**LEVEE DISTRICT No. 1
Of SUTTER COUNTY**

**STAR BEND SETBACK LEVEE
SUTTER COUNTY**

Board Action

**Consider approving Permit No.
18191 to construct a setback
levee and degrade existing
project levee; and to modify
existing irrigation system**

PROPOSED SETBACK LEVEE CROSS SECTION

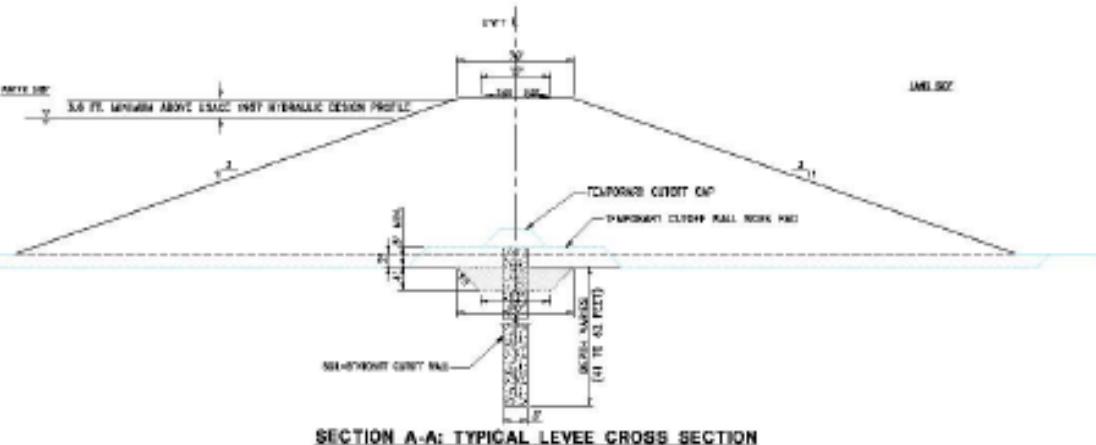
- Minimum freeboard above 1957 hydraulic design flow profile – 3 feet
- Underseepage Exit Gradient – 0.5
- Foundation slurry cutoff wall
- Levee Embankment Material – Title 23 and USACE standards
- Levee cross section – 20-ft crown; 3:1 levee side slopes

PROPOSED CUTOFF WALL PROFILE

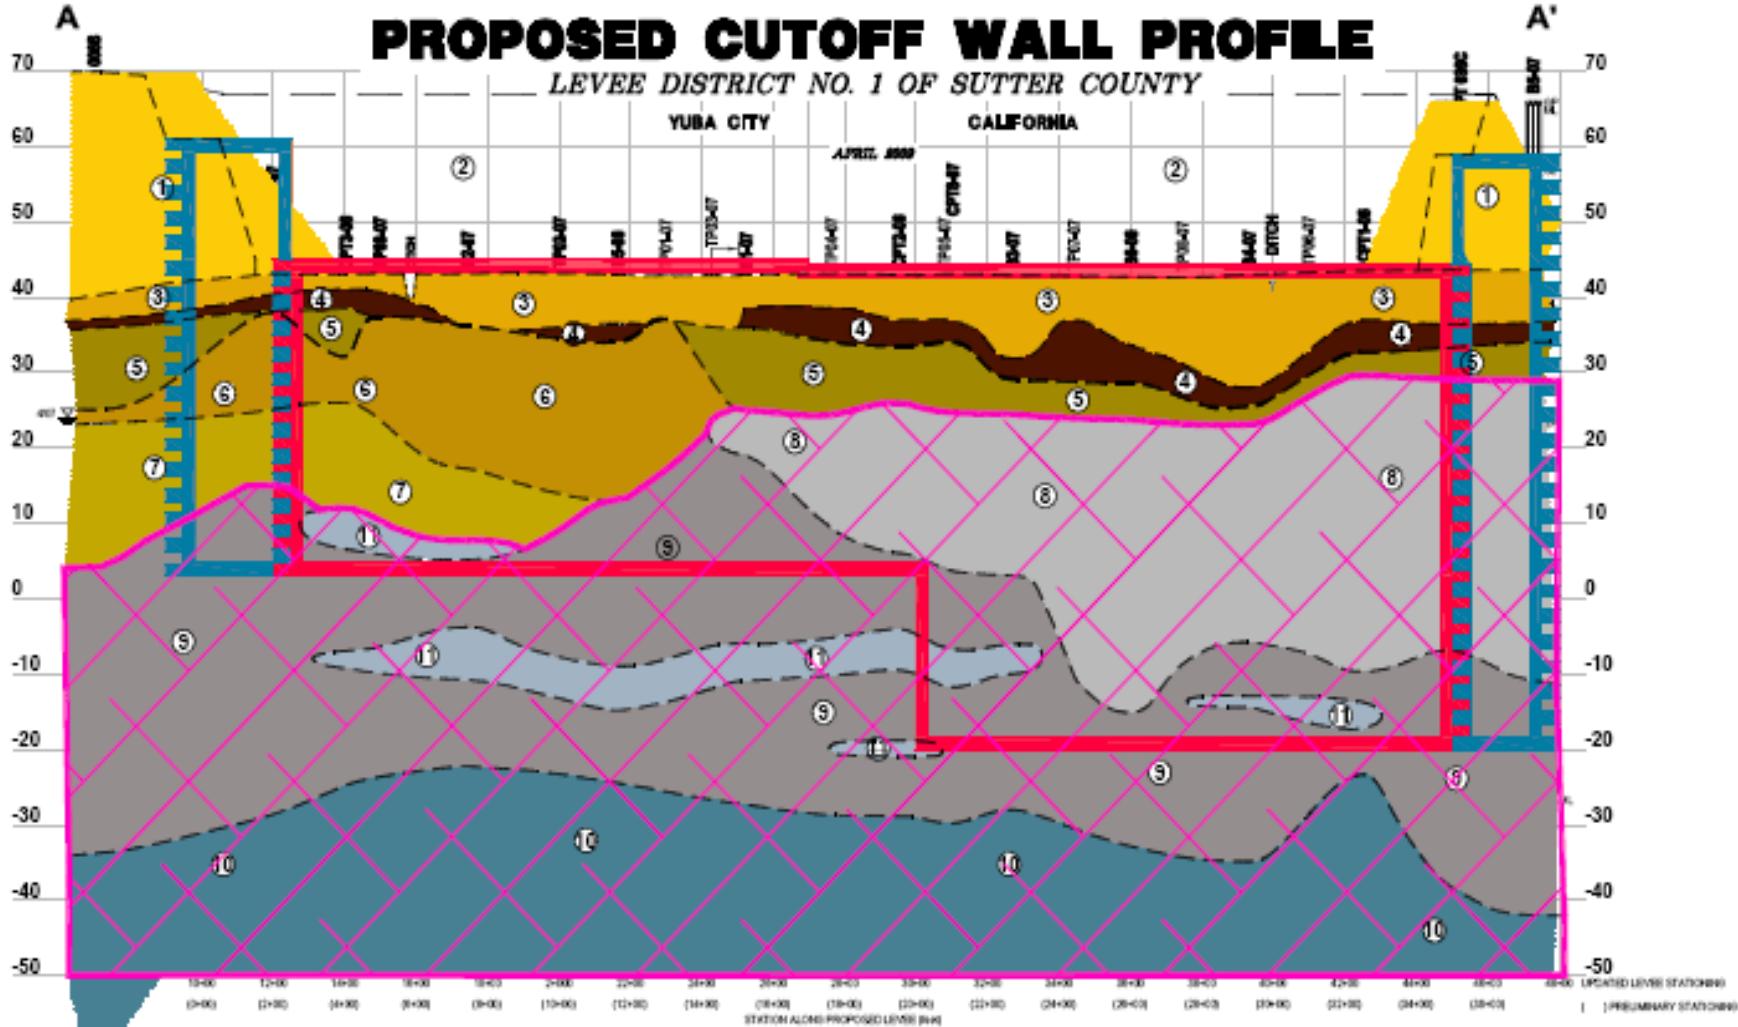
- 1-3 ft below the ground surface, 5-20 ft thick layer of very hard clay/silt (top of Modesto Formation)
- 20-50 below ground surface, 10-45 ft thick layer of clay/silt adequate to terminate slurry cutoff wall
- Subsurface soil conditions north, south, and west of proposed alignment similar
- Soil-bentonite slurry cutoff wall reduced exit gradient from 0.6 to less than 0.1
- Slope stability analysis meets Corps requirement
- Settlement Analysis –immediate and primary settlement

**Pre- and Post-Project Water Surface Profile of Lower Feather River Right Bank
With Setback Levee at Star Bend for 1-in-100 and 1-in-200 AEP Flow Events, and 1957 Design Profile**

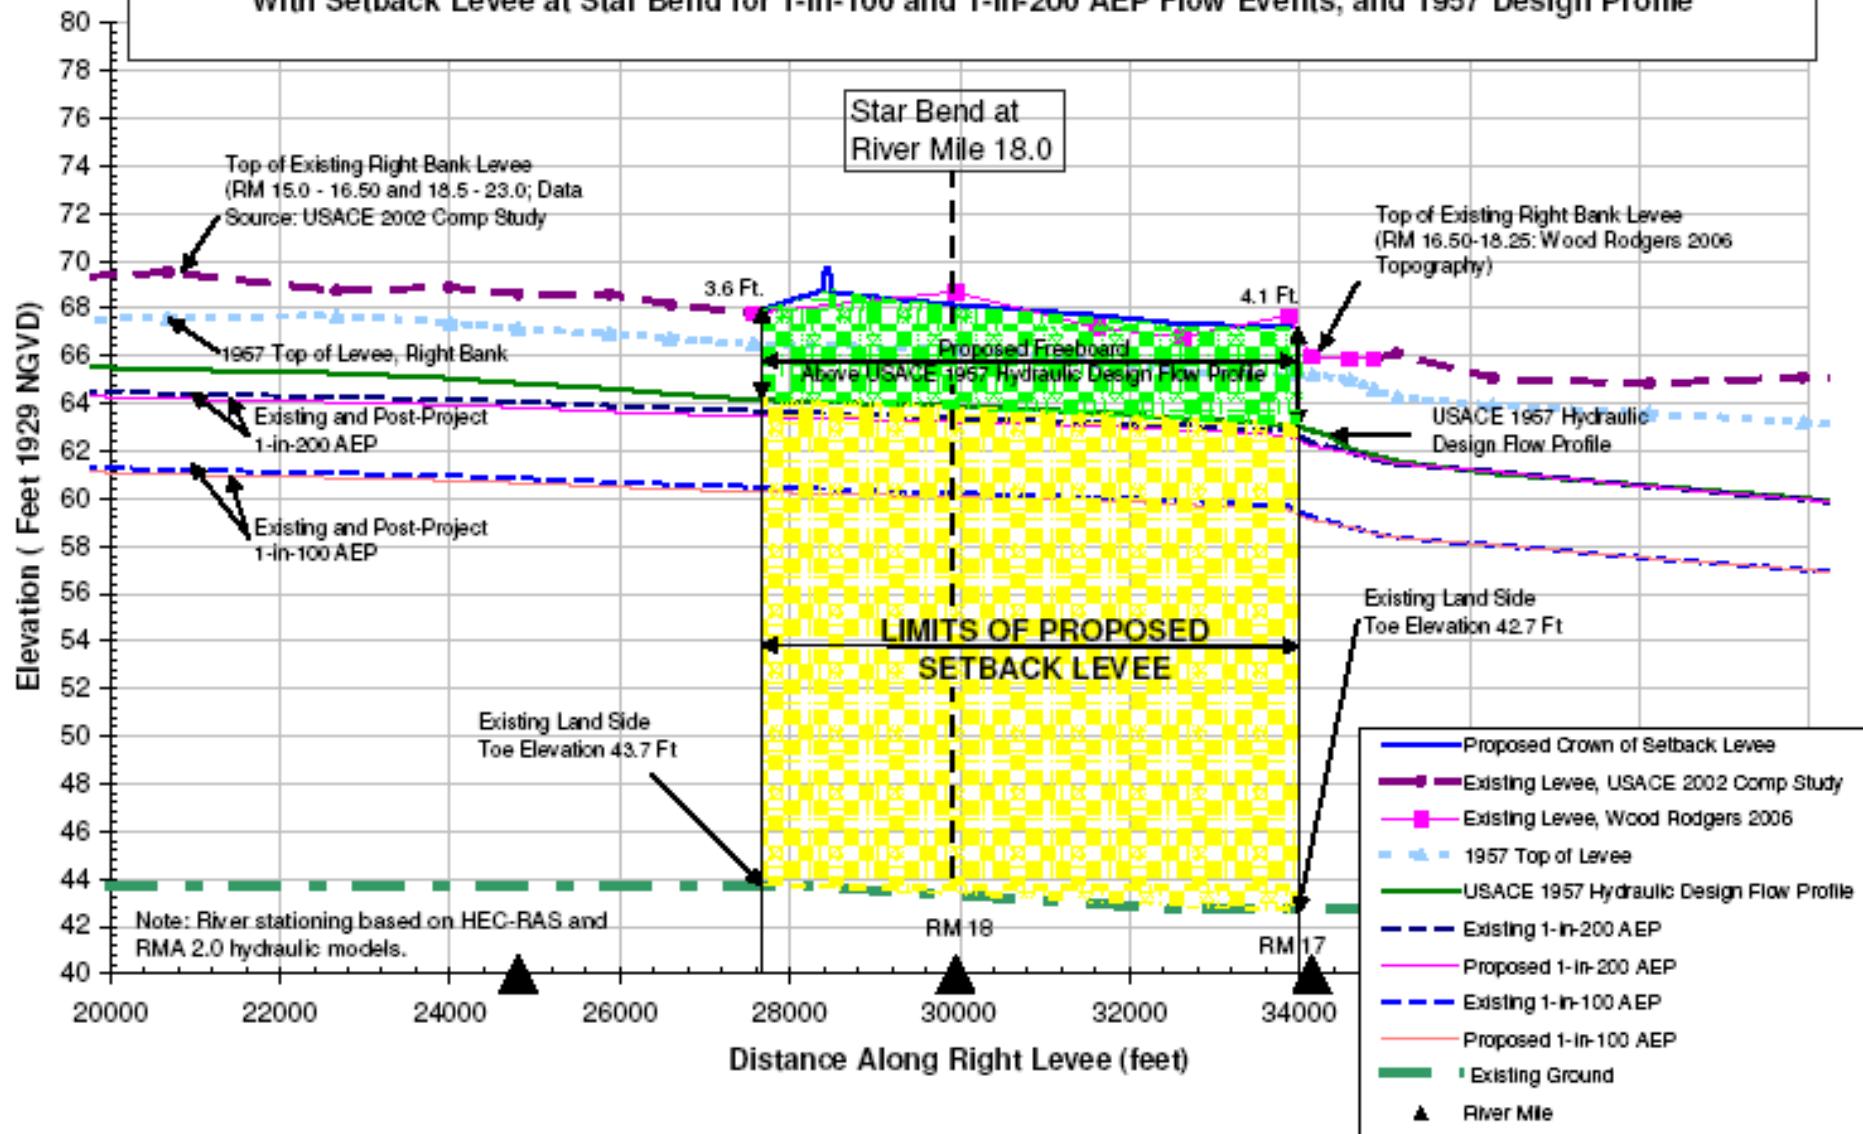
- WSEL reduction beginning at RM 17.00 to RM 23.00, with maximum WSEL 0.24 ft at RM 18.25 (1957 design)
- WSEL rise between RM 16.50 and 16.75 with maximum WSEL .04 ft. (1957 design)

Figure 12
 Proposed Simultaneous Degradation (in Levee Height)
 of Existing Levee System at Star Bend - Feather River Mile 18.0
 With Degradation as Borrow Material Starting August 7

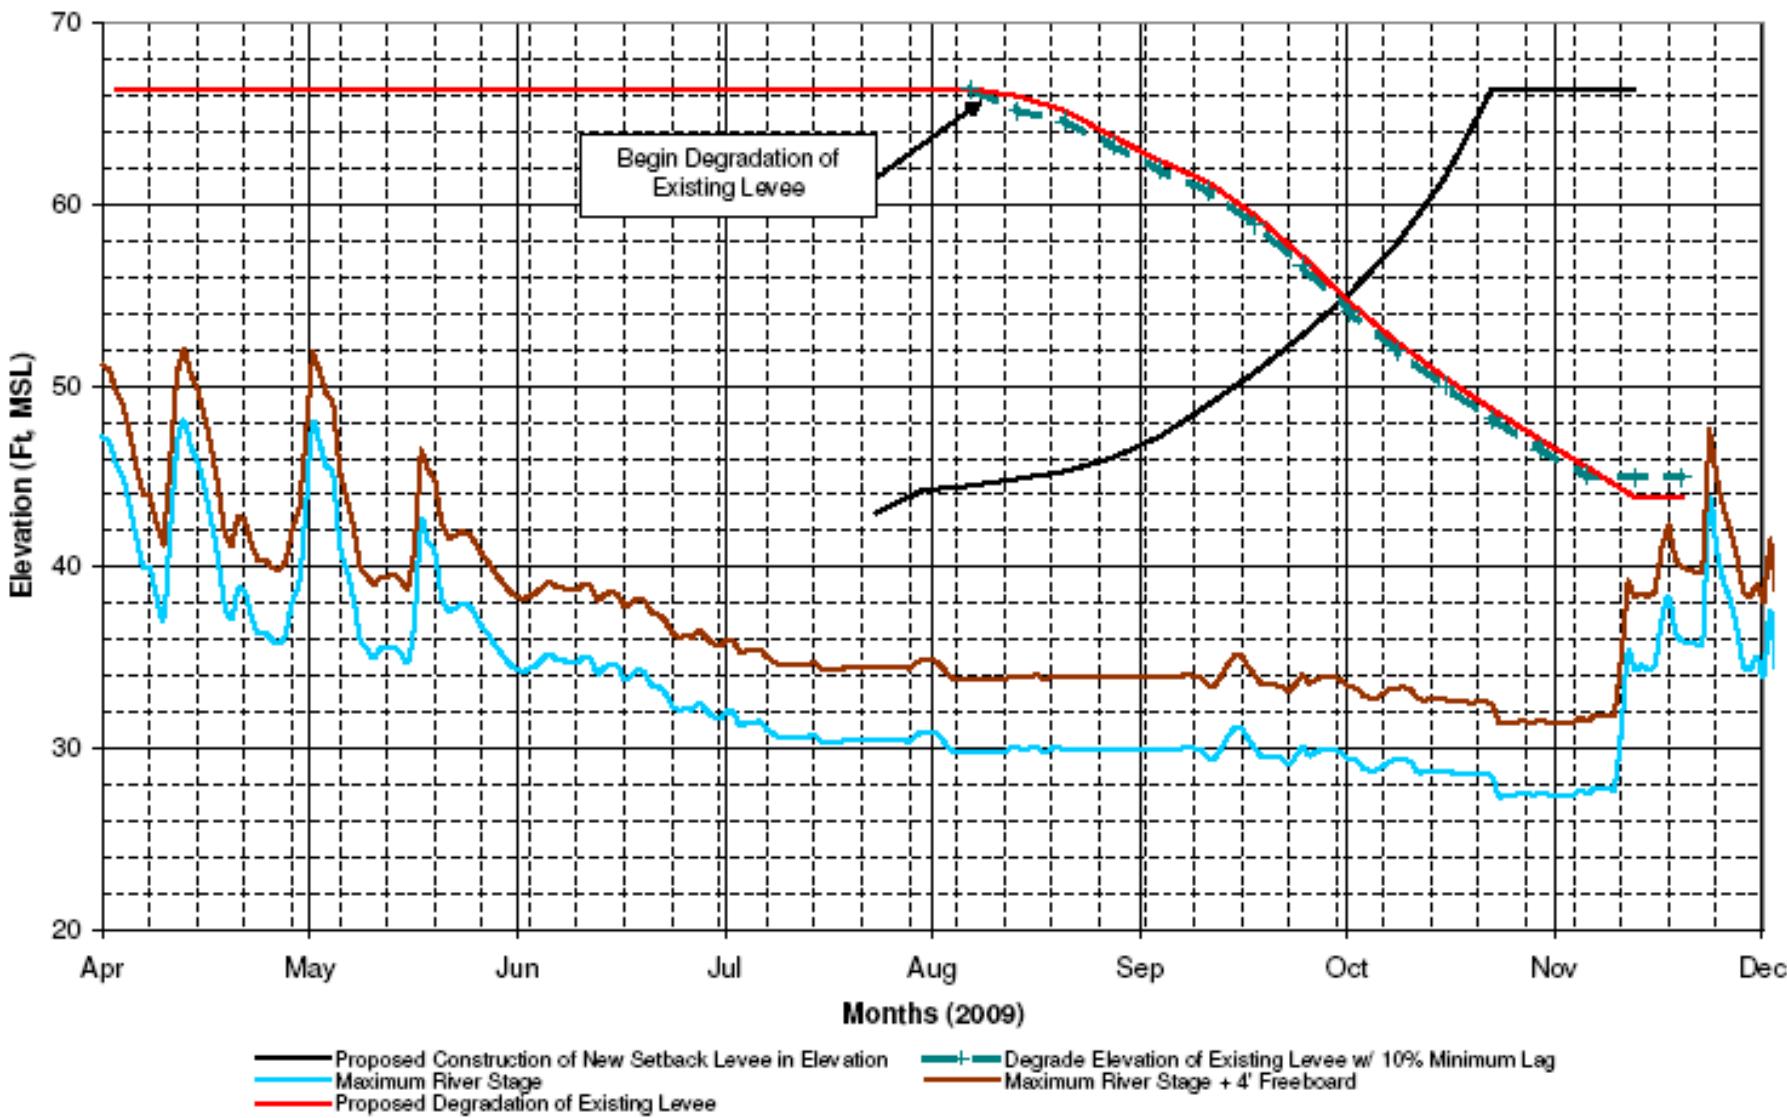
- 408 approval – mid-May
- Bid Opening – May 15
- Start Construction – June 1
- Degrade Levee for Tie-in – June 8
- Complete foundation cutoff wall – August 7
- Start embankment construction – July 27
- Start degradation of existing levee for borrow material – August 7 (at least 10% of new levee embankment complete)
- Complete construction of embankment – October 16
- Complete degradation of existing levee – October 23
- Complete project – October 31

LEVEE DISTRICT NO. 1 OF SUTTER COUNTY
 RIGHT AND LEFT BANK RMA2 OBSERVATION PROFILES AND
 MODIFIED HEC-RAS CROSS SECTIONS FOR SETBACK LEVEE AT STAR BEND

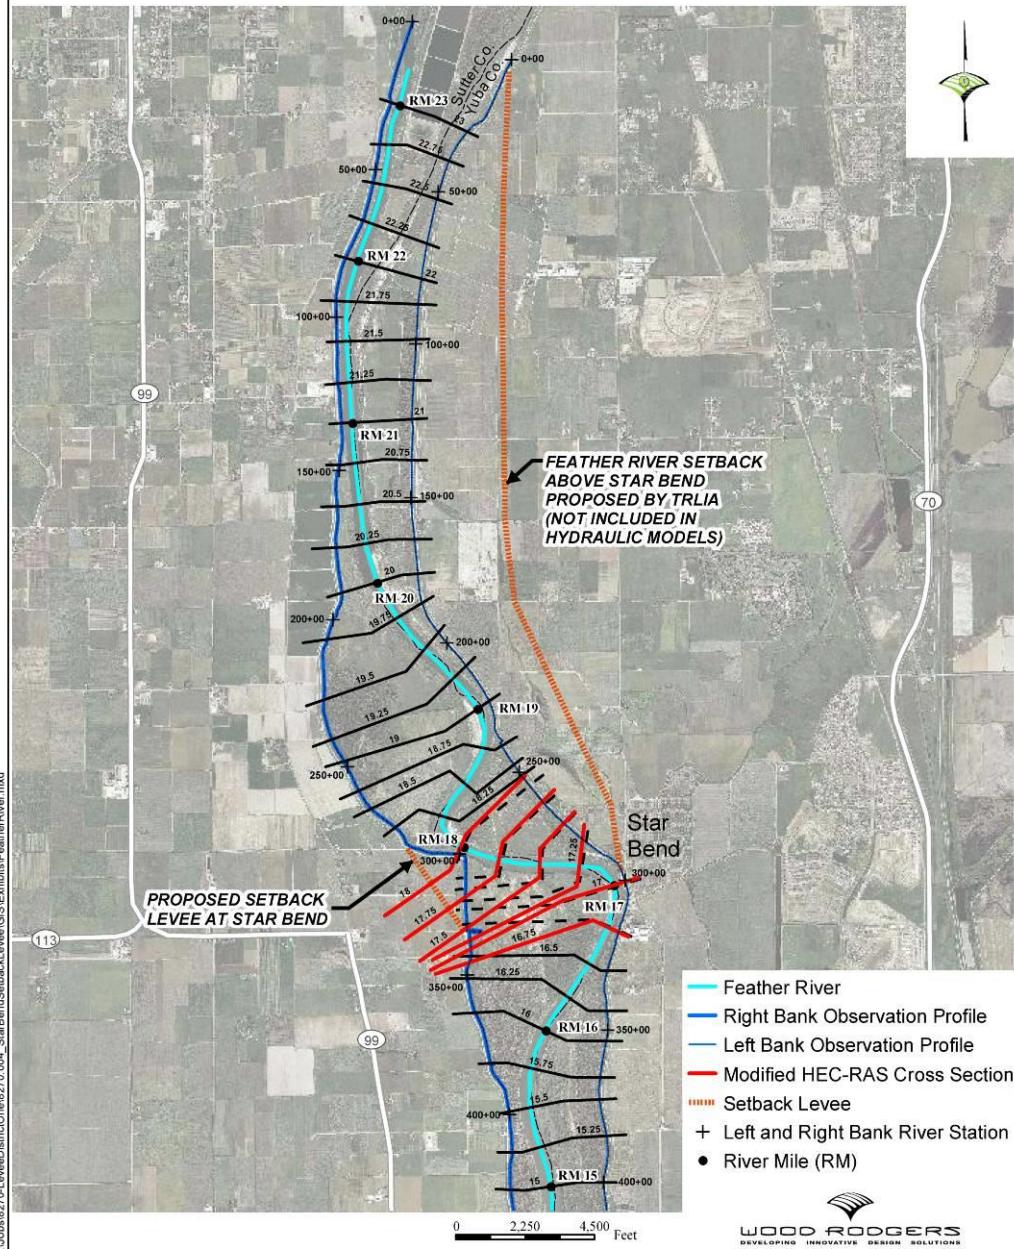
- RMA2 MODEL –without TRLIA setback levee project
1. Maximum WSE reduction 0.64 ft between RM 18.0 and 18.25 with lesser reductions upstream (1957 design)
 2. WSE elevation rises from 0.01 ft to 1.11 ft between RM 17.995 and RM 17.495
 3. Velocity along the right bank are reduced 4-5 feet/second to 3ft/sec
